Stride Treglown Response to SE comments dated – 1/10/25 (M Furnish)

- Comments to be read in association with Plan No. SRP1077-NVB-00-XX-D-L-2103.

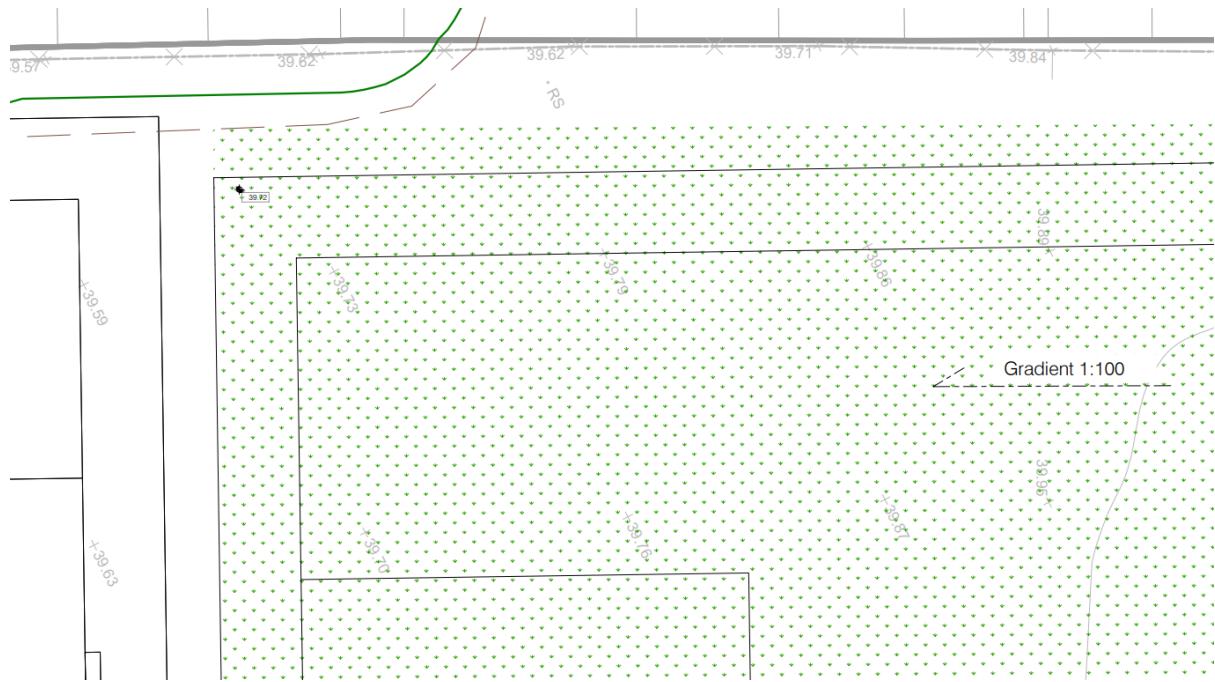
1. To Sport England gradients – see 1:100 on plan attached and extracted below
2. This is reverting to pre-existing gradients prior to the temporary school installation
3. Spot Height Explanation
 - a. Light grey are existing
 - b. Black are proposed
 - c. Existing below hatched reinstated playing field will be regraded to a consistent gradient between the four proposed levels in each corner

Attached is a snip of the attached plan, which shows the existing spot heights, all be it quite small. These confirm that the levels are 'no worse than existing', the original levels are compliant with SE gradients.
